TABLE 3 - COMPARATIVE LIST OF DESIGN CHANGES

R O W	Original Architectural Design	Amended Architectural Design
1	<div>Cover Page</div> <div></div>	<div>Cover page - updated Frenchmans Road streetscape presentation, additional drawings sheets</div> <div></div>
2	<div>DA01 Site Plan</div> <div>Total GFA: 3,785.2m2</div> <div>FSR: 1.397:1</div> <div>Total No. of Beds: 86</div> <div>Total No. of ILUs: 2</div> <div>Total No. of Rooms: 80</div>	<div>DA01 Site Plan Rev B dated 1 June 2021</div> <div>Total GFA: 3,458.4m2 – GFA reduced by 326.8m2</div> <div>FSR: 1.276:1 – FSR reduced by 0.121:1</div> <div>Total No. of Beds: 86</div> <div>Total No. of ILUs: 2</div> <div>Total No. of Rooms: 79 – reduced by 1 room</div>
3	DA02 Site Analysis	DA02 Site Analysis Rev B dated 1 June 2021 – no change
4	DA02a Site Analysis – Location Plan	DA02a Site Analysis Rev B – Location Plan dated 1 June 2021 – no change
5	DA03 Lower Basement Floor Plan	DA03 Lower Basement Floor Plan Rev B dated 1 June 2021 – no change

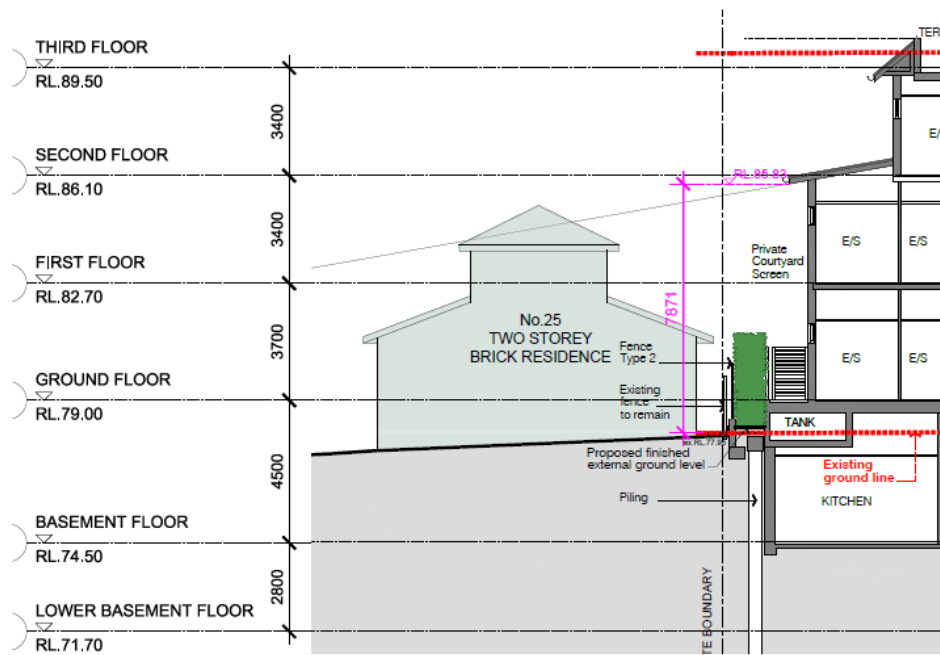
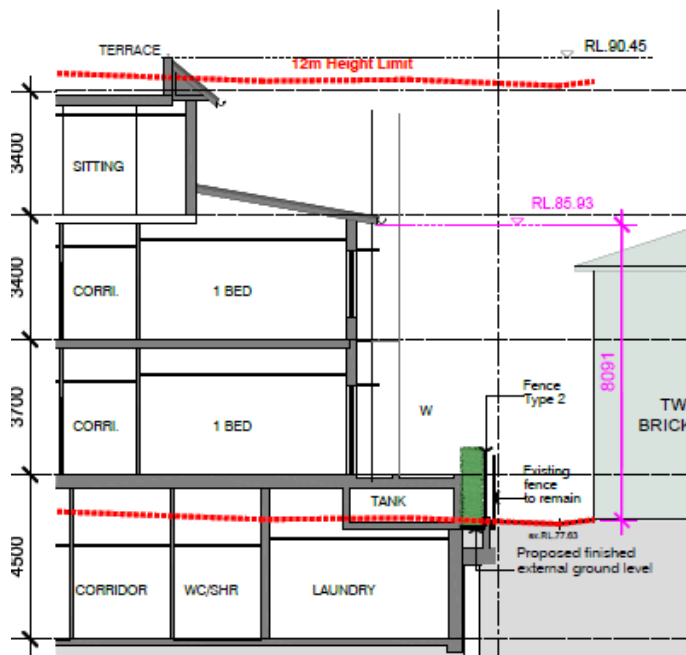
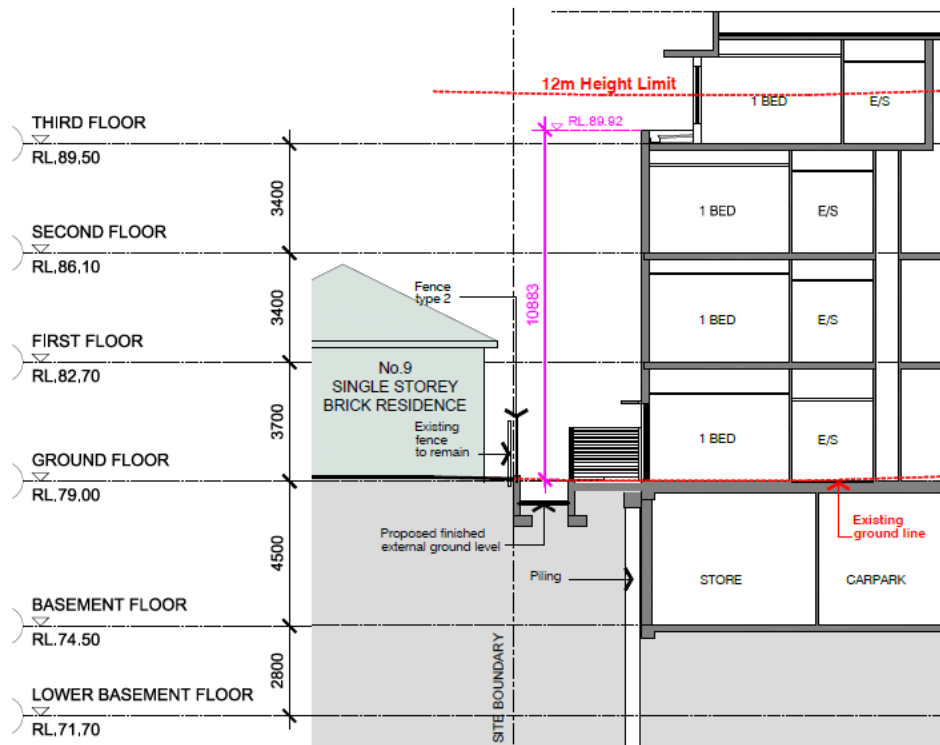
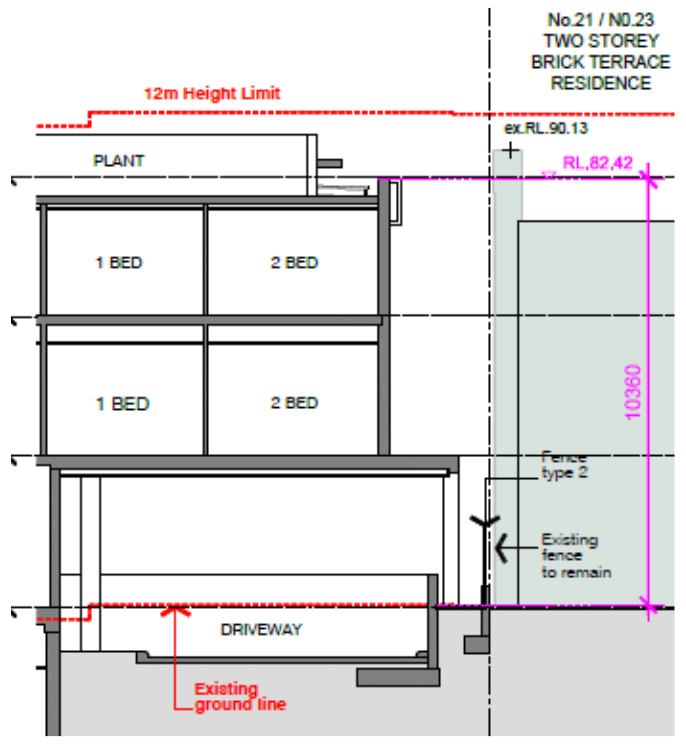
Original Architectural Design	Amended Architectural Design
No comparable drawing in original drawing set	
DA13a Sections @ Boundary Rev A dated 1 June 2021 – new drawing to demonstrate wall height adjacent to boundaries to respond to DEP comments	
 <p>Section G to eastern boundary with 25 McLennan Ave – wall height 7.871m setback 2.55m, upper level setback 3.95m</p>	 <p>Section J to western boundary with 27 McLennan Ave – wall height 8.091m setback 2.51m, upper level setback 3.96m</p>
 <p>Section J to western boundary with 9 Frenchmans Road – wall height 10.88m setback 4m, upper level setback 5.5m</p>	 <p>Section K to eastern boundary with 21 Frenchmans Road – wall height 10.36m setback 2.35m, upper level setback 3.85m to plant enclosure</p>
